Wylfa Newydd Project

Request for Non-Material Change no.4

Working Hours

PINS Reference Number: EN010007

Figure 3-1 Figure D5-5 as submitted in the DCO application

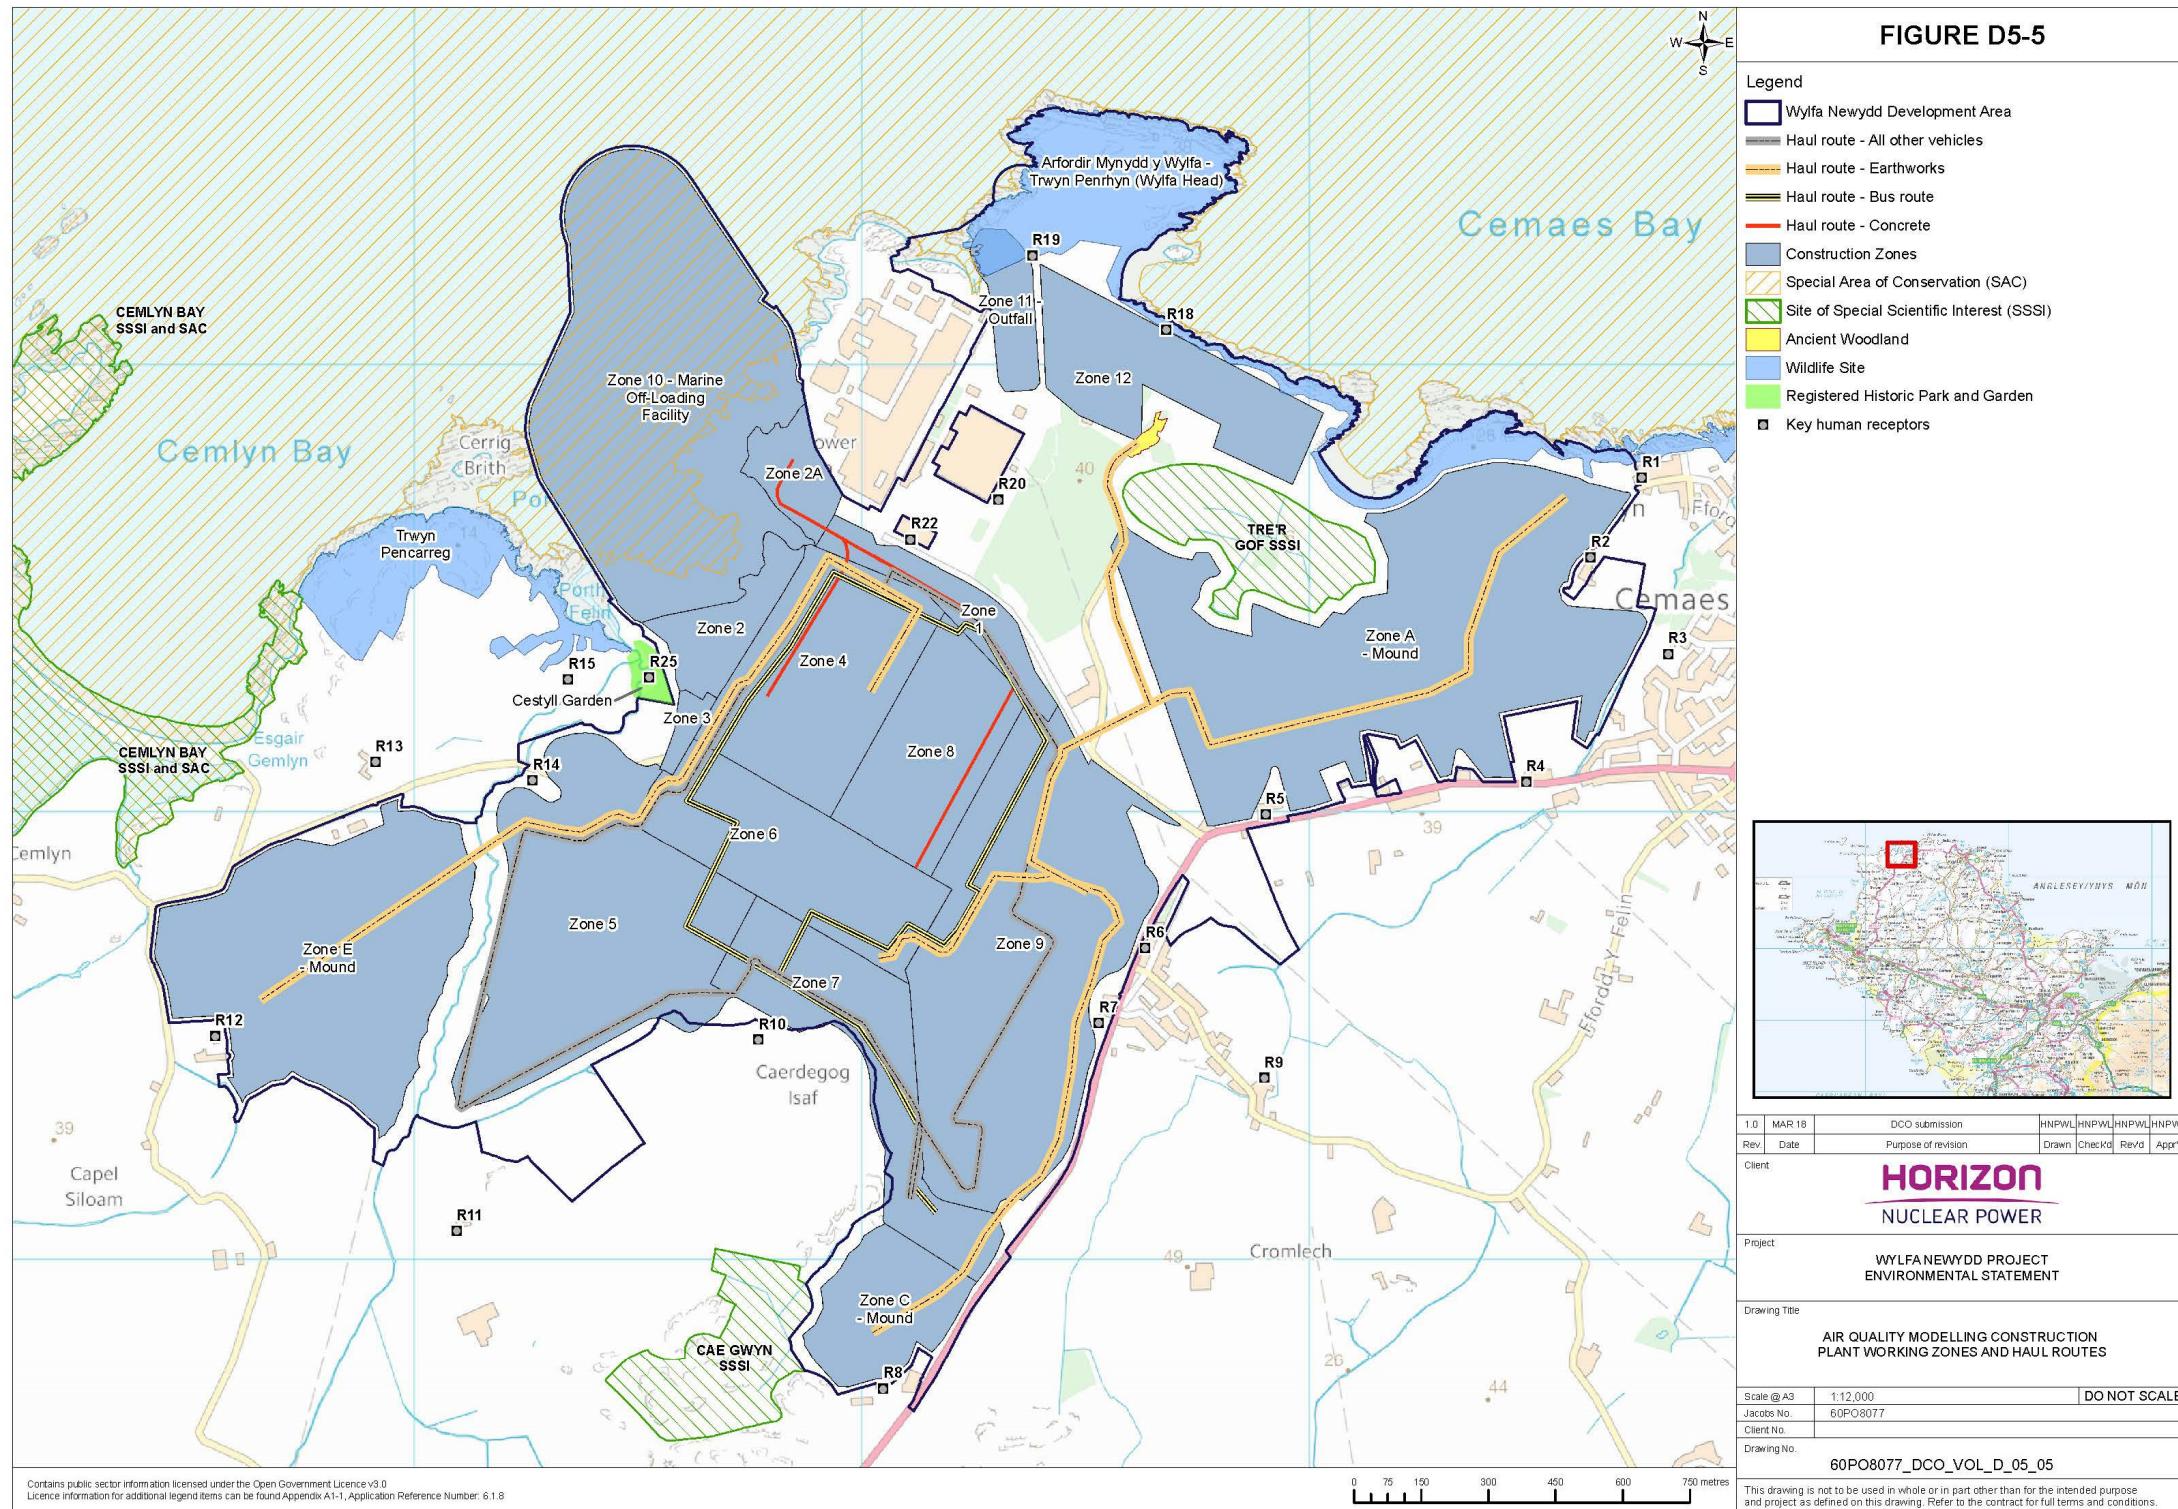
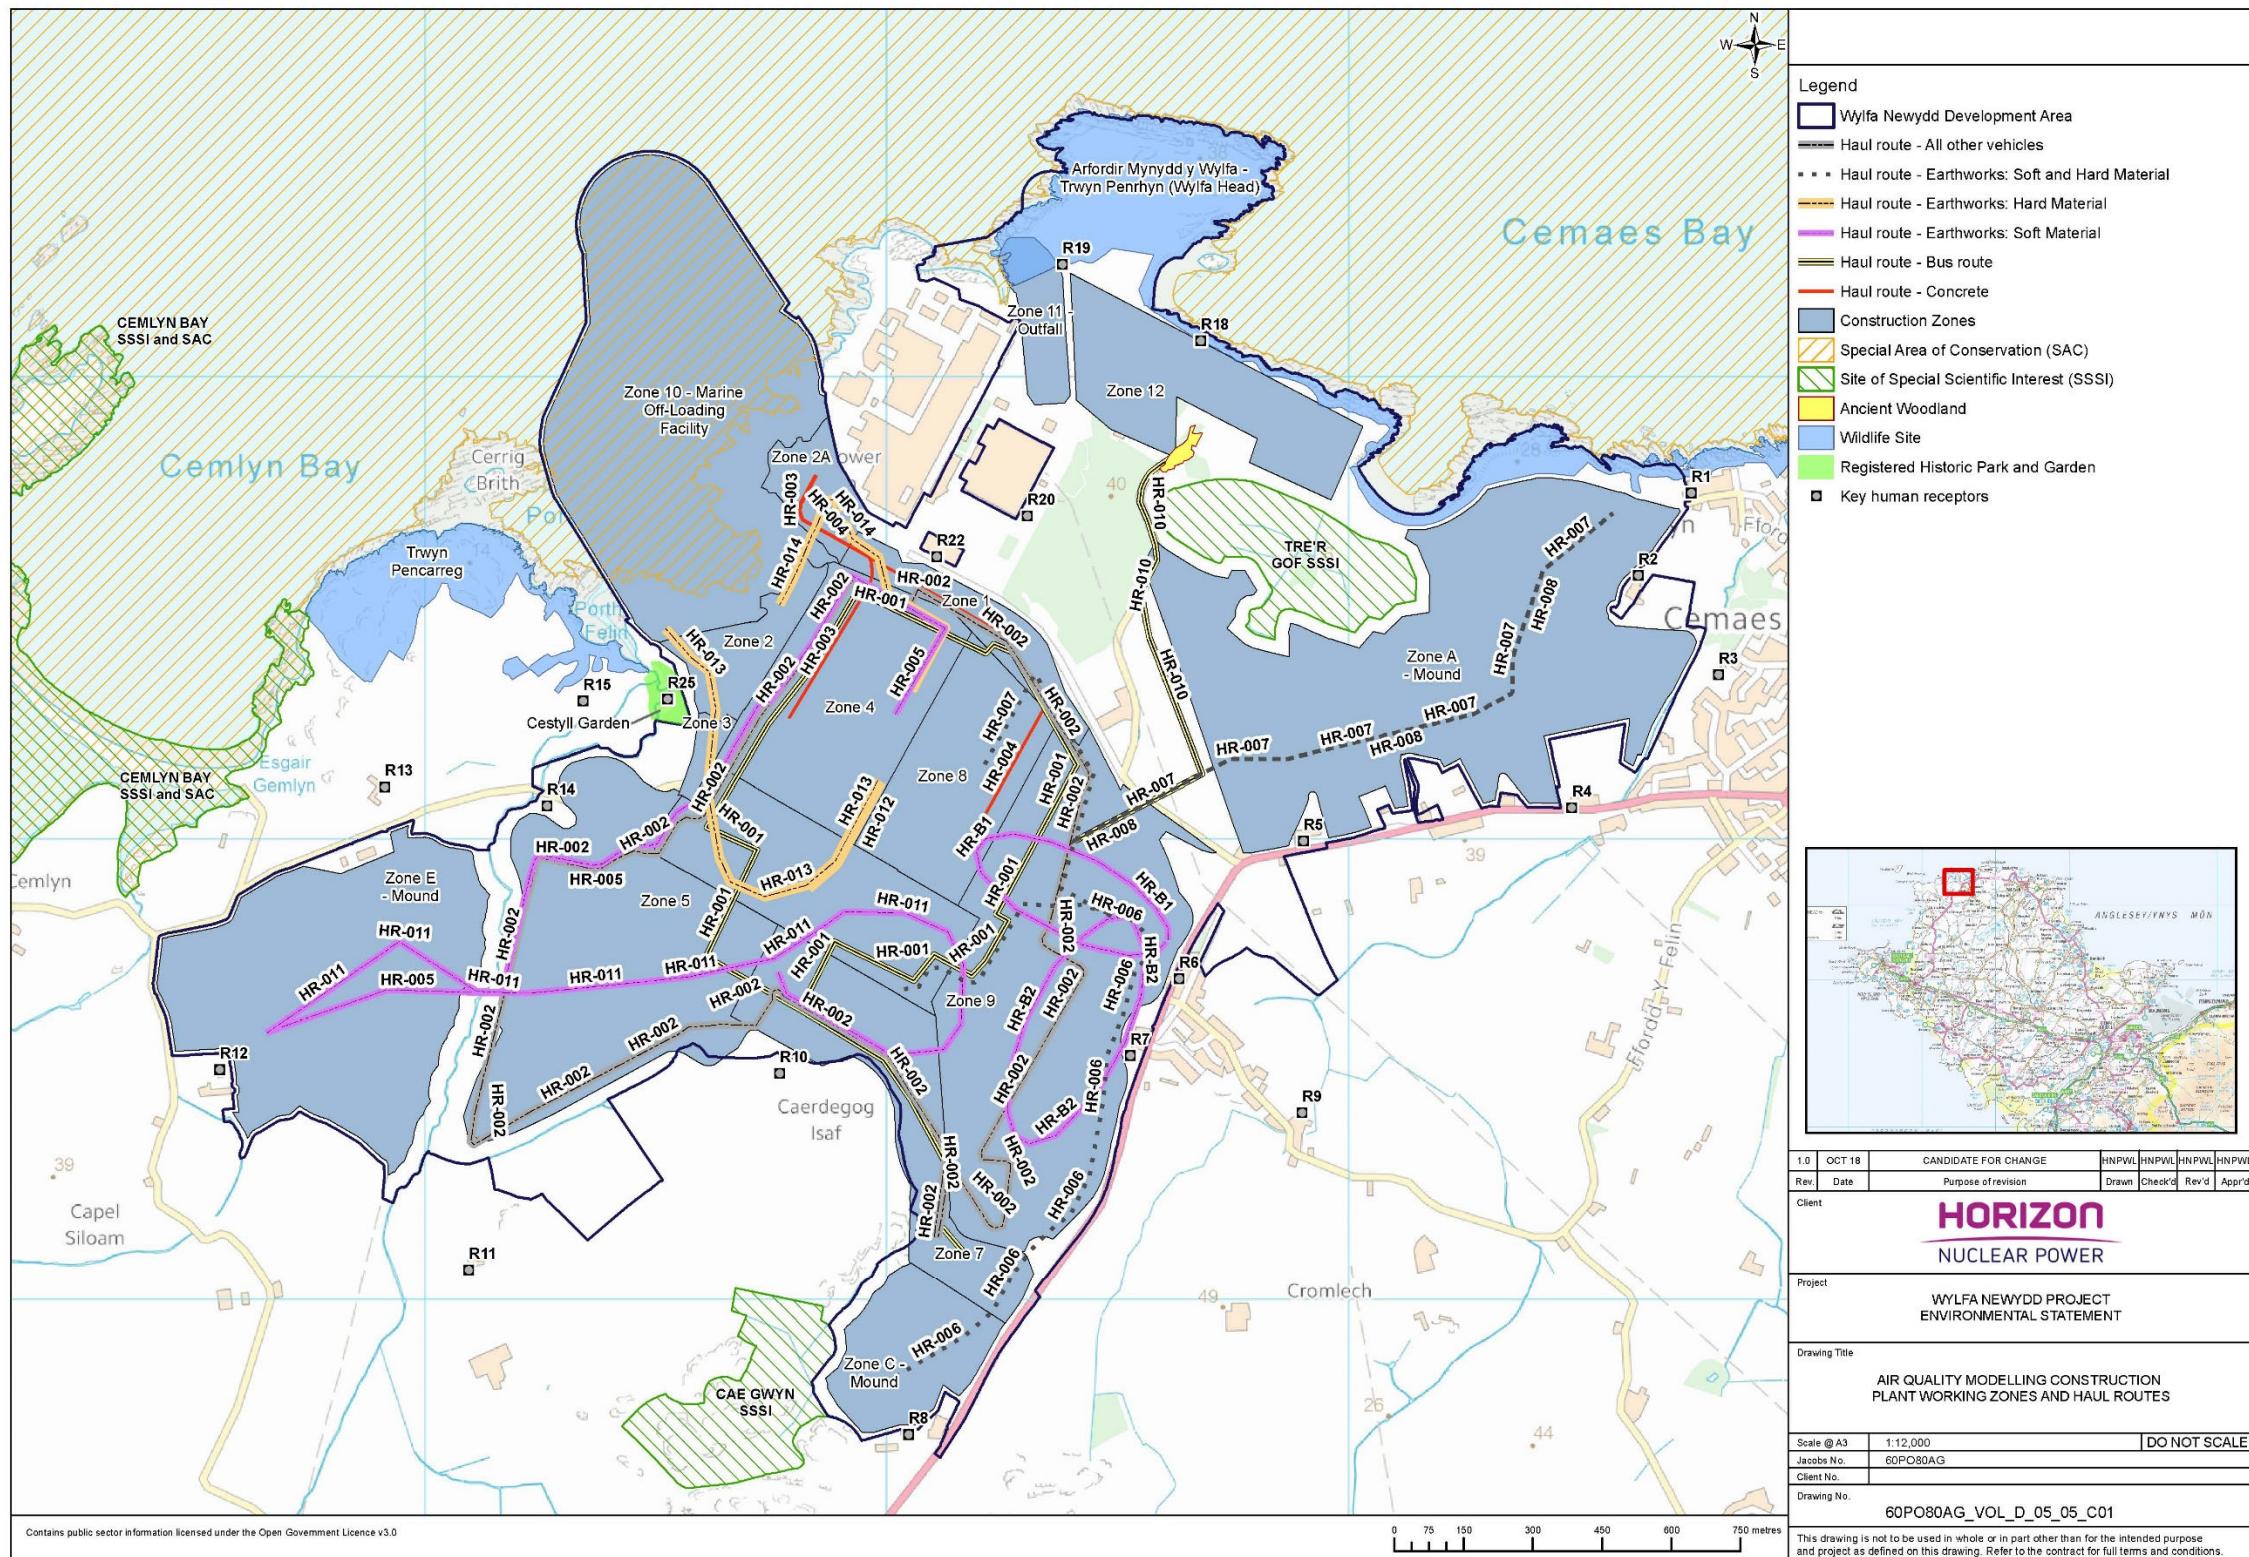
2.5.7 A description of the air quality assessment for human and ecological receptors is provided in the following sections. Before and after extracts showing changes to the new haul routes relative to air quality receptors are shown in Appendix 1-2 (see Figure 3-1 and Figure 3-2). The overall conclusions of the effects of the proposed change on the quantified residual effects of the DCO application are summarised in paragraphs 2.5.27 and 2.5.32.
